# Historic Preservation Board Regular Meeting Agenda

## **Historic Preservation Board Staff Report for April 14, 2021 Meeting**

COR #20-05 Request of Paul Bryan for: Approval to renovate and expand the existing home at 807 Maryland Avenue located in the College Quarter Historic District. Zoned: R-2. Parcel ID # 07-22-30-8760-00-172

[COR 21-02. Request of Z Properties for renovations to the property at 1530 Wilbar Circle built in 1926 on the Winter Park Register of Historic Places.](#)

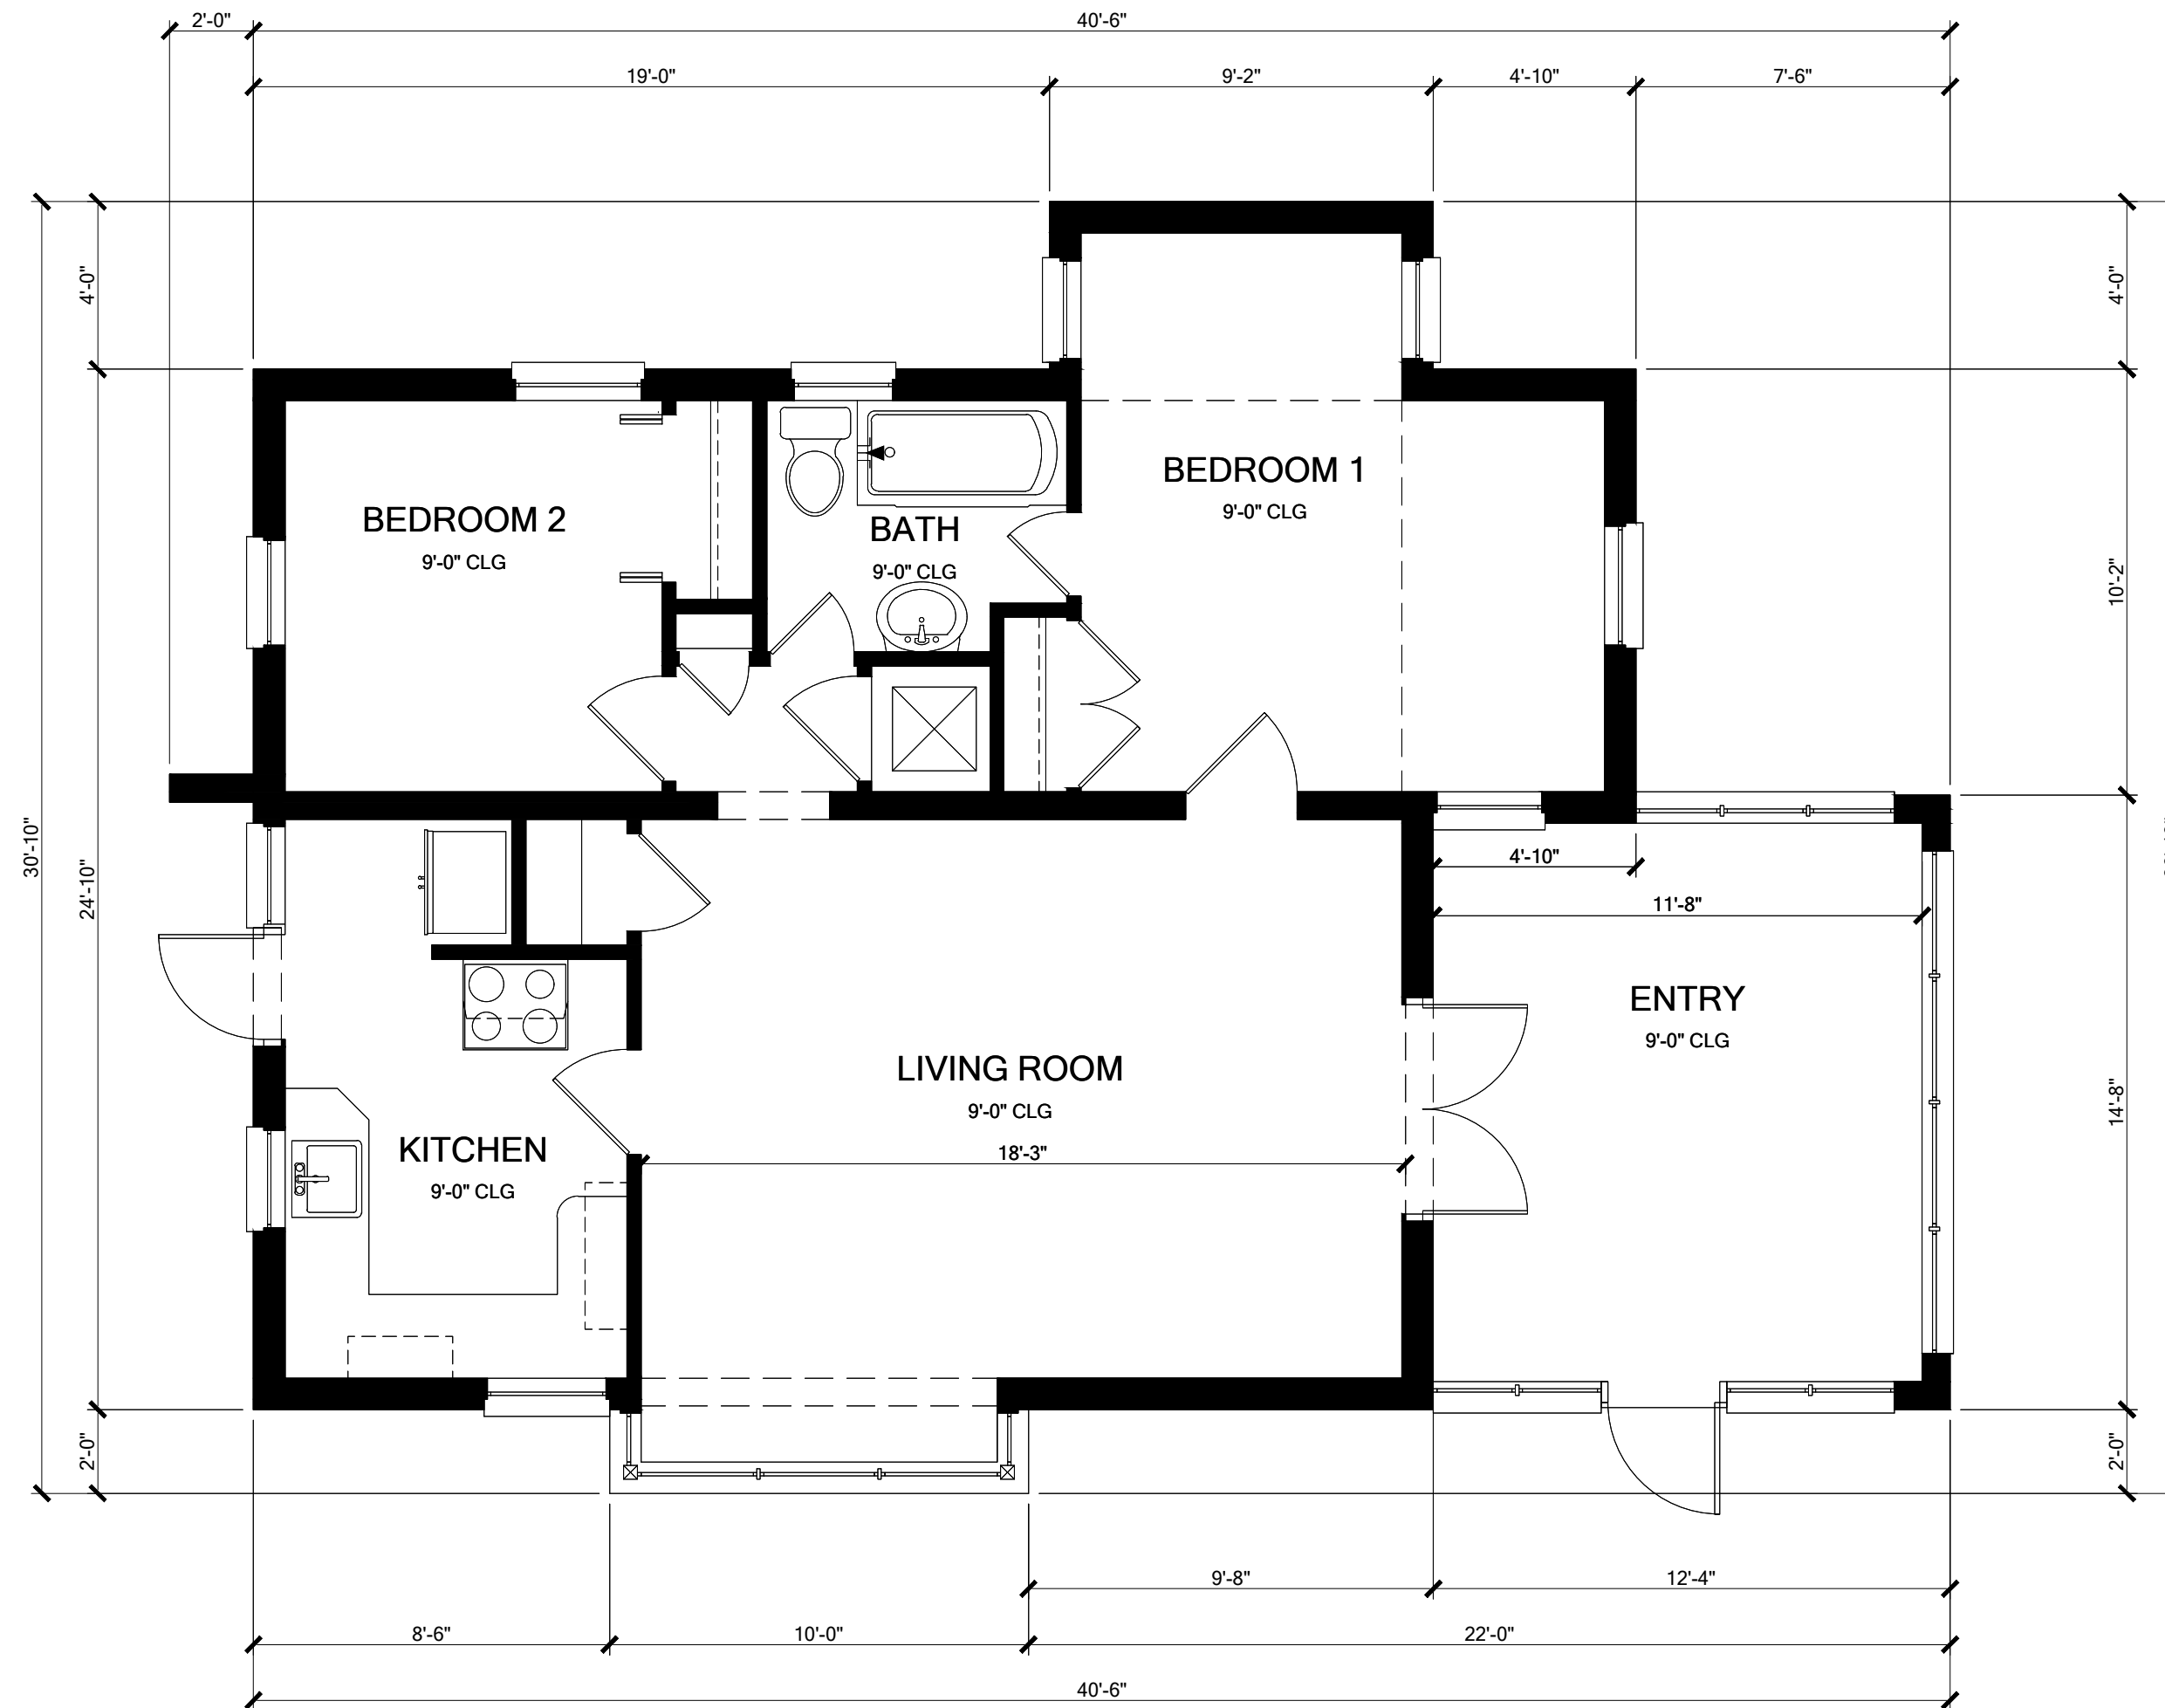
The project is a new home of 2,048 sq. ft. in size with a front covered porch of 362 sq. ft. The home exceeds the minimum building setbacks with a 37-foot front setback to the porch (30 ft. required) and 8-foot interior side setback (7 feet required). The applicant is maintaining the existing street side setback of 7.7-9.8 feet. There is also 19.5 feet of unimproved right-of-way from the property line out to the curb of Huntington Avenue. The floor area ratio is 32% versus the permitted 55%. The impervious coverage is 43% versus the permitted 65%. There is one variance requested as part of this application:

1. Variance for a rear setback of 5 feet in lieu of the required 10 feet for the attached one-story, two-car garage.

As the staff has indicated on prior applications, the historic designation, whether individually or within a district is ideally a win-win for both parties. The City is enabled to have architectural control to maintain the look and appearance of our architectural heritage and the property owner may be granted setback variances when deemed appropriate and not impacting the affected neighbors. In this case the affected neighbor has an existing older home at the same 5-foot setback, as requested from the same property line. That adjacent neighbor could also rebuild habitable living space, (subject to HPB approval) at a conforming 7-foot side setback, which is not materially different from the 5-foot setback requested however, in this circumstance only for a garage.

**THE STAFF RECOMMENDATION IS FOR APPROVAL OF THE PROPOSED BUILDING PROGRAM AND VARIANCE REQUESTED, AS PRESENTED.**

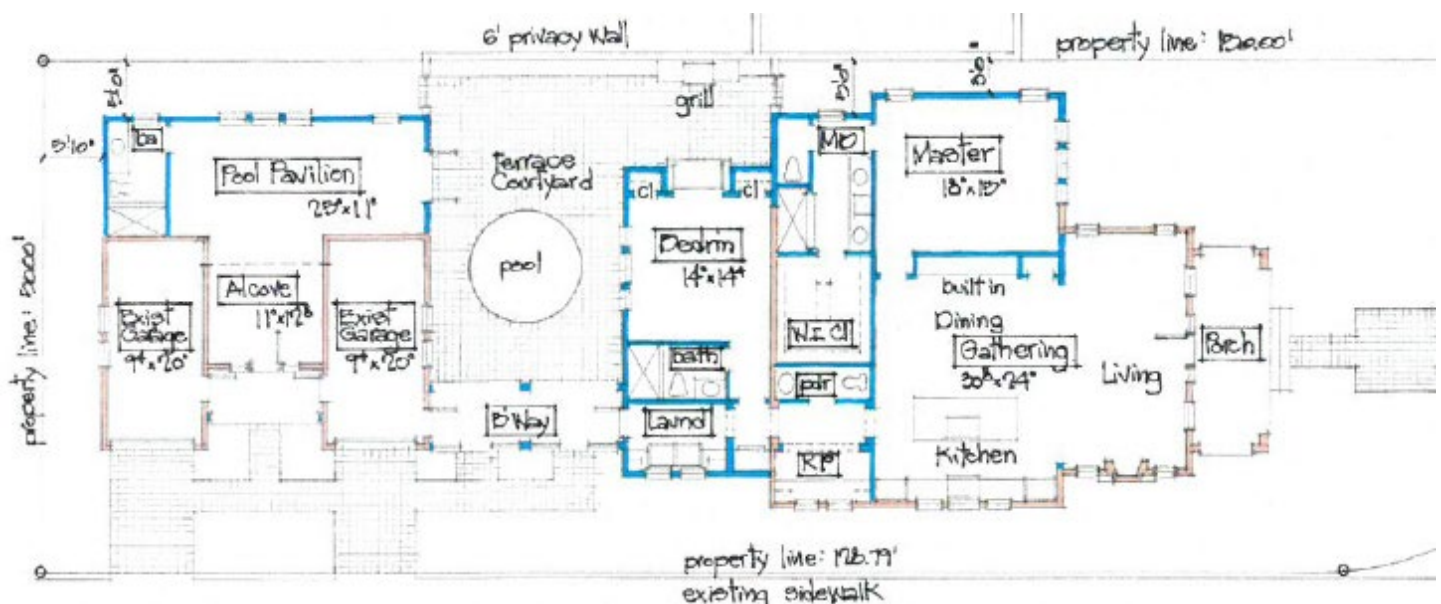
The applicant is asking to rebuild the new two-story, two-car garage at a non-conforming 7-foot rear setback. This is a new variance that was not presented to the HPB in October 2020. At that time, the plans (shown below) maintained the existing one-story structure (no second floor). See Code excerpt below. The reason for this Code prohibition on gable ends facing the adjacent neighbor, is to prevent the mass and two-story height (and windows) of a gable end located just 7 feet from their property, which in this case, is the front yard of the neighbor's home. Staff's conditions of approval will remedy this situation.

*d. Accessory buildings in rear yards: The exterior walls of accessory buildings shall not exceed 10.5 ft in height measured from natural grade to the roof sheathing surface unless placed at the same setback as required for the principal building. Additionally, accessory buildings located less than 10 feet from an interior side lot line must have a sloped or flat roof, e.g., the side wall adjacent to the lot line cannot be a gable end wall.*

1. That the three vents on the front façade be retained.
2. That the new garage design be revised to only have gable ends facing the street (north) and interior (south) side of the structure.

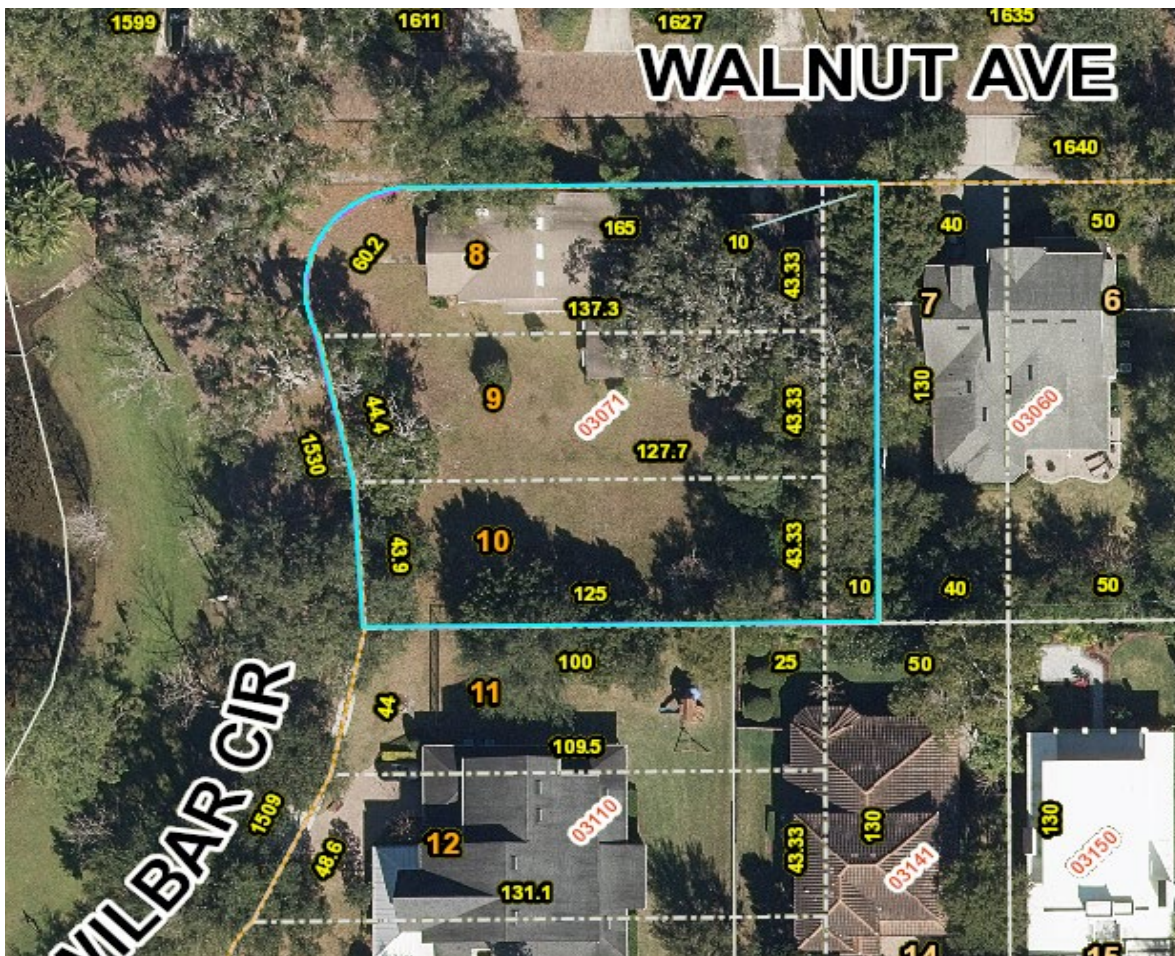
The existing home is white stucco, which the applicant plans to continue. You will note that they are opening up the front porch, maintaining the existing window fenestration and French roof braces. Those are all important architectural design elements dating to the 1926 heritage. They also will maintain, for the most part, the roof vents on the street facing facades but staff notes that on the front façade the plans reduce them from three to one. Staff will propose maintaining that gable end facade as-is and three vents as exists today.

The major design issue concerns the proposed new two-story, detached garage. The plans shown to the HPB in October called for preserving the existing one-story garage and modifying the interior floor plan to create a "pool pavilion" or cabana area for a small pool contemplated in to the courtyard area between the home and the garage. The applicant is now requesting HPB approval to demolish the one-story garage and rebuild a two-story structure. They believe upon closer look, the existing garage (see pictures below) is non-functional and unusable. However, another motivation is to create the ability (with an internal stair) to have a bonus room (labeled as an attic, but will be, air-conditioned living space. If the use is solely as an 'attic; then one doesn't need windows on all four sides for the room. In order to have it function as living space and to maximize the square footage upstairs, every side is a gable end giving it the function and appearance of a two-story structure.

A gable end faces the street, which is what we see on the existing garage. However, now there is also a gable end facing the adjacent neighbor's property/home as well as the other sides. Today, the adjacent neighbor's view is only of the one-story garage wall and roof sloping away from the property line. It is minimally intrusive given that visible height and appearance.
